IN THE DRAWINGS:

REMARKS

Amendments To Drawings

FIG. 1

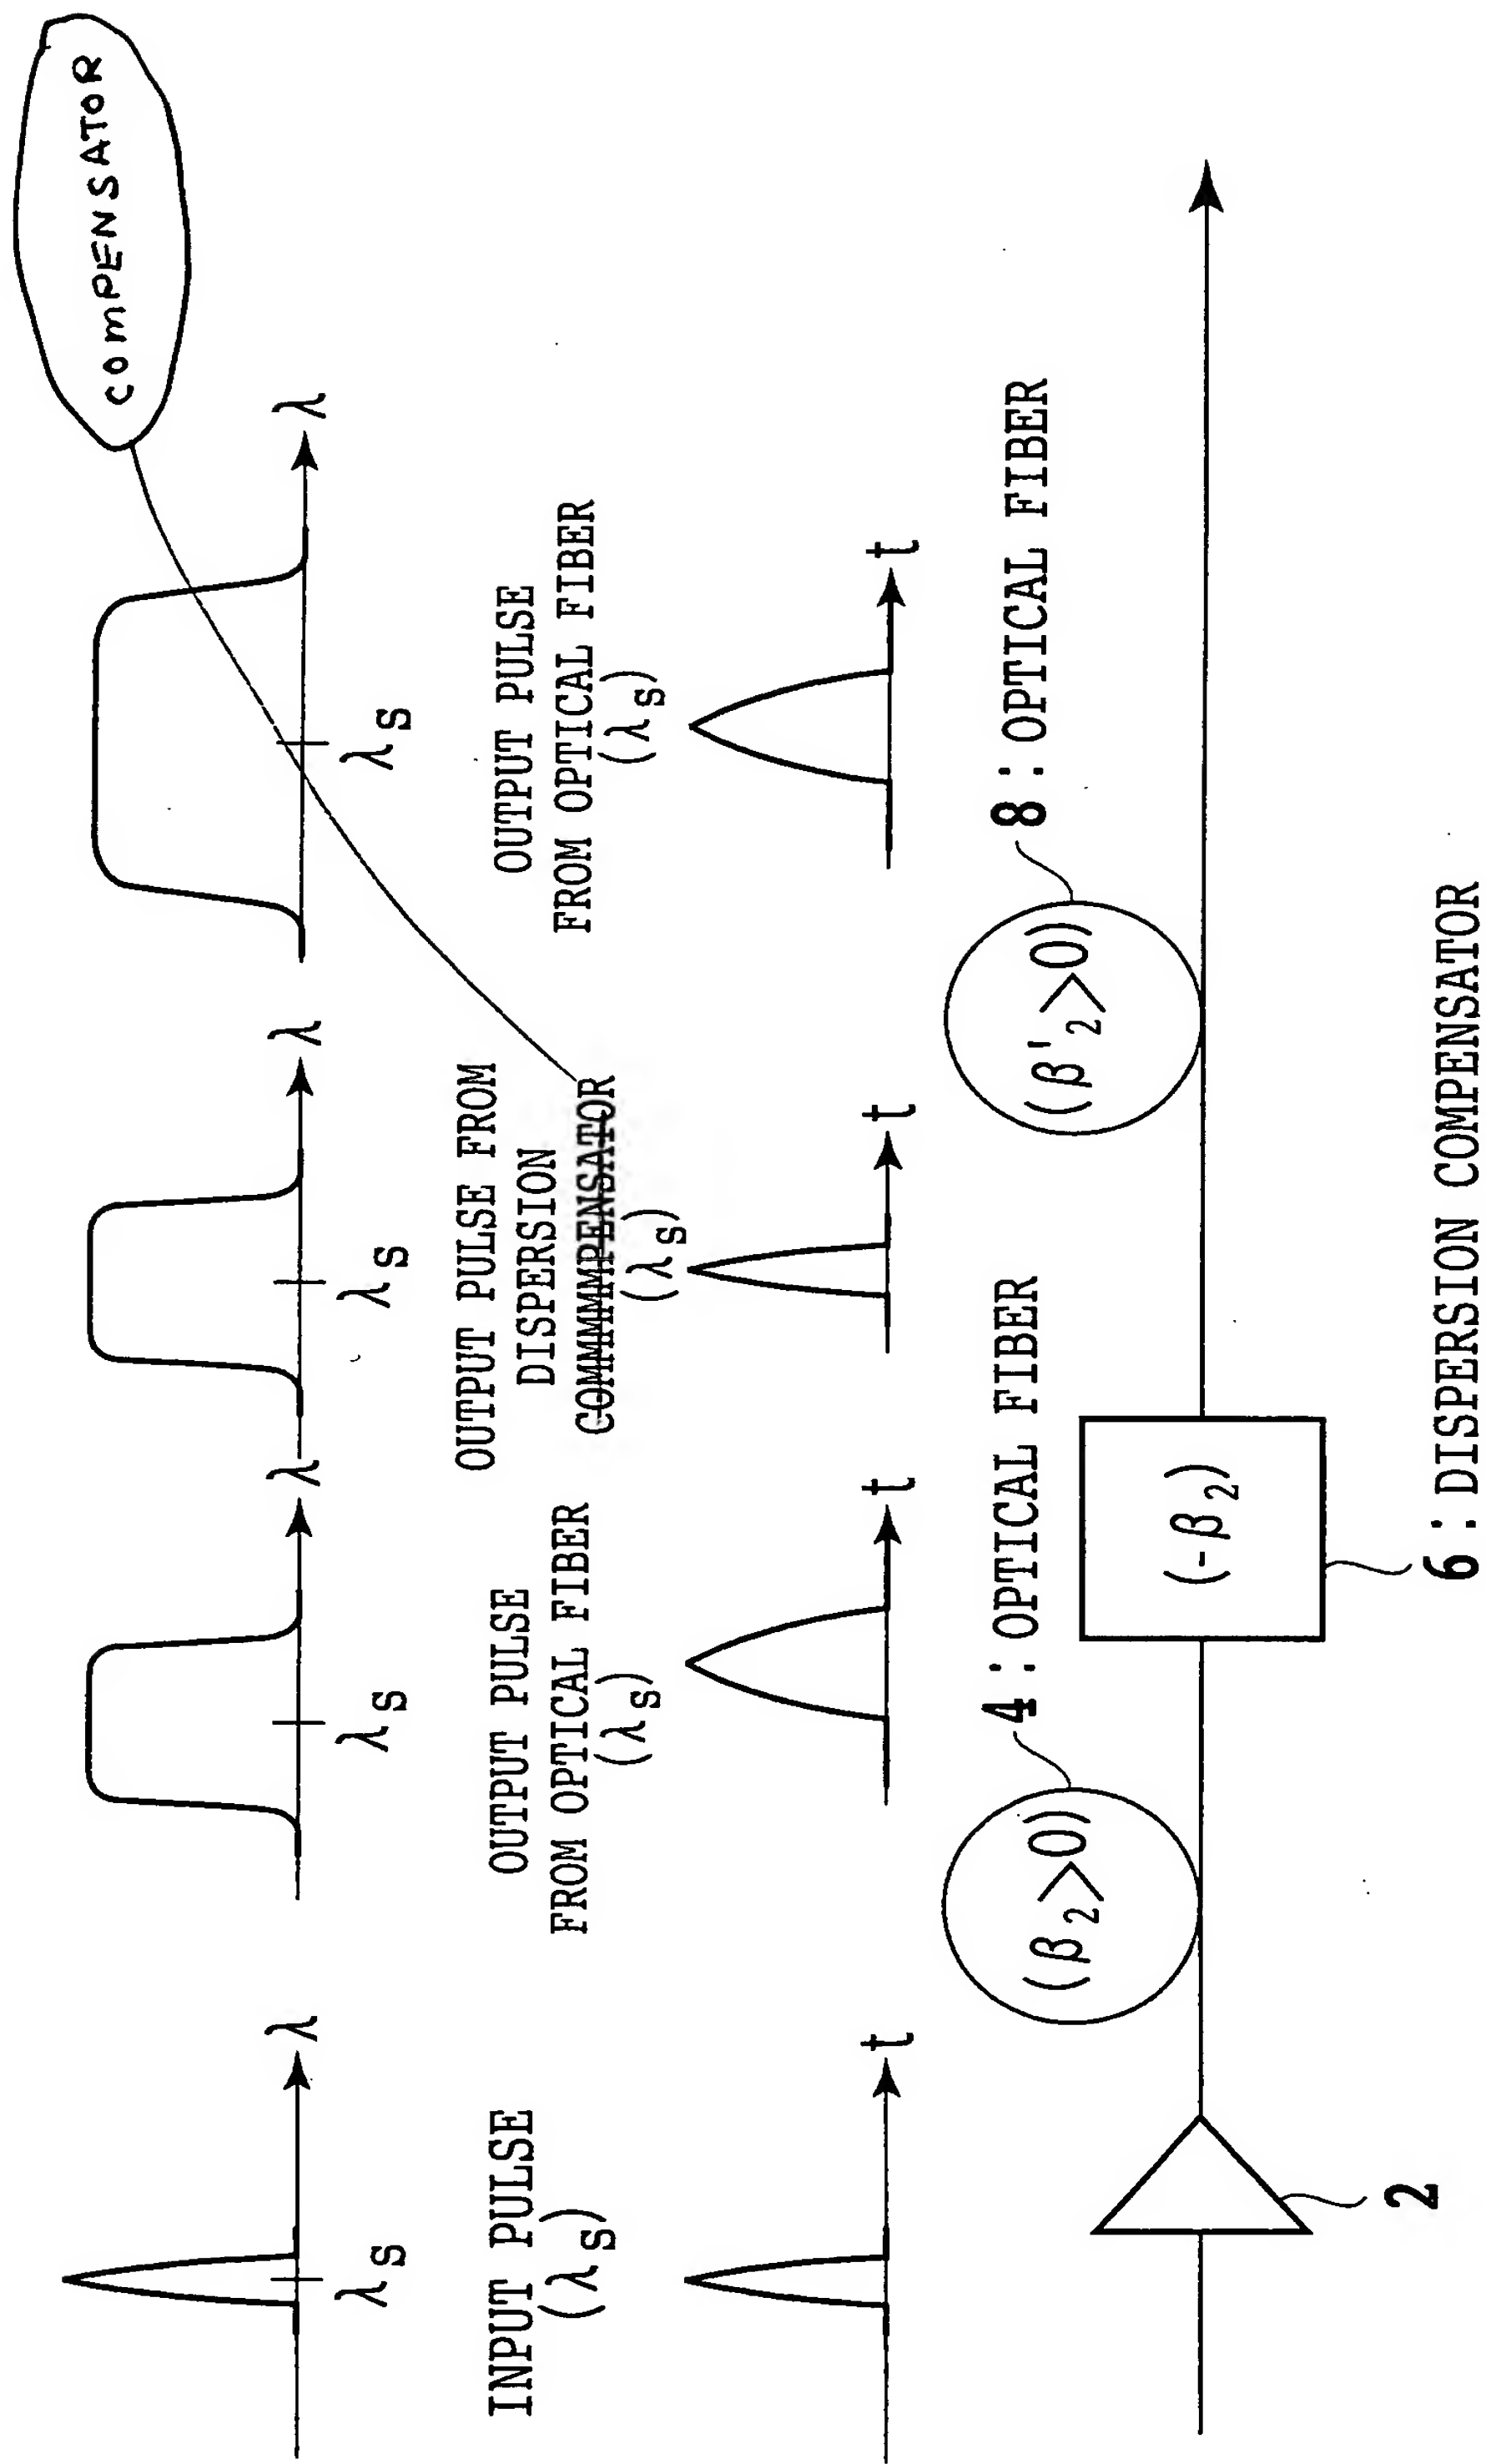
In FIGs. 1, 3, and 4 the term "COMMMMPENSATOR" is replaced with the term --COMPENSATOR--. In FIG. 4, the labeling for amplifier "48" is replaced with --52--.

In item 1 of the Office Action, the Examiner objects to the drawings because of the misspelling of the word "compensator" in FIGs. 1, 3, and 4. (Action at page 2).

In FIGs. 1, 3, and 4, the term "COMMMMPENSATOR" is replaced with the term --COMPENSATOR--. Reconsideration and withdrawal of the objection to the drawings are respectfully requested.

FIG. 7

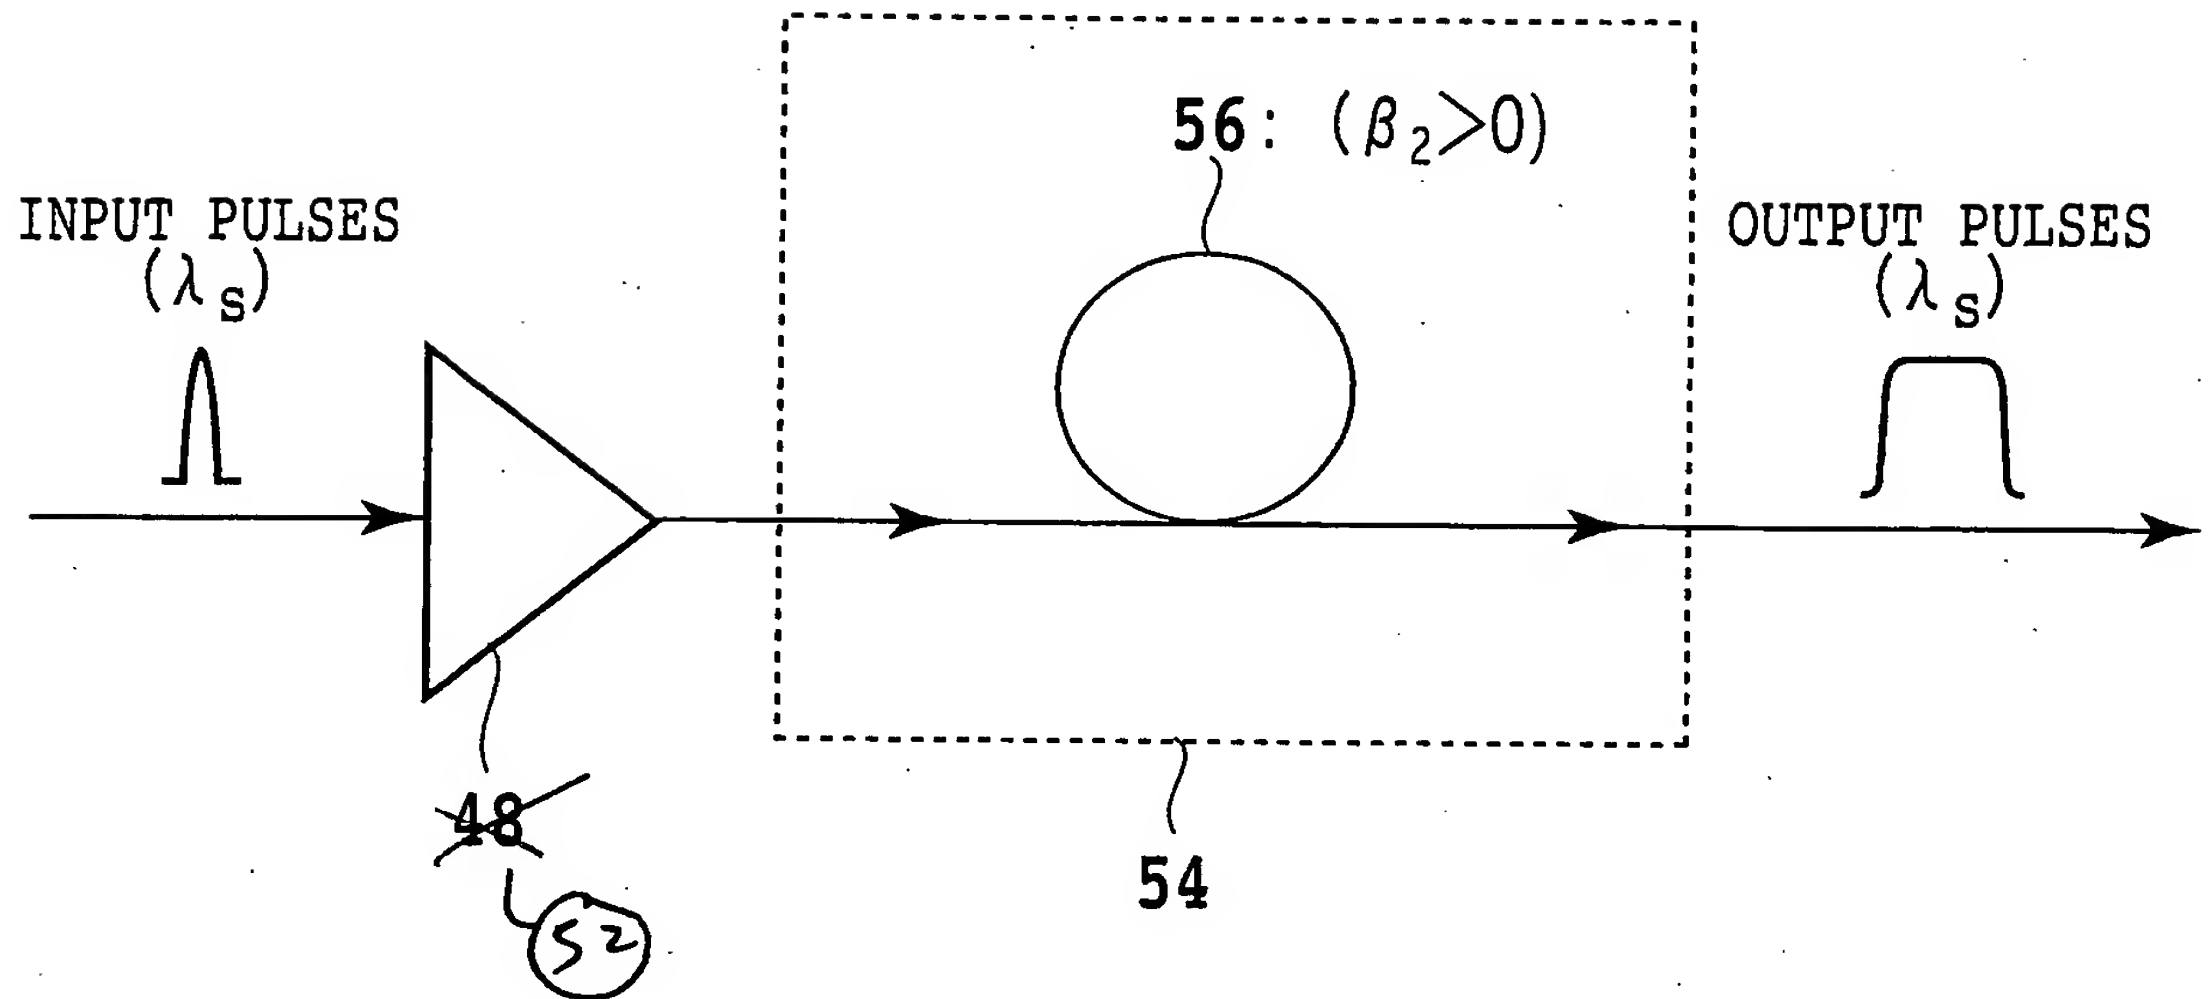
FIGs. 1, 3, and 4 are amended to correct the spelling of the term --COMPENSATOR--. FIG. 7 is amended to correct an informality and label correctly label amplifier "48" as amplifier --52--. Support for the amendment is found on page 26, lines 10-11 that refers to FIG. 7 o "optical amplifier 52. No new matter is being presented, and approval and entry are respectfully requested.
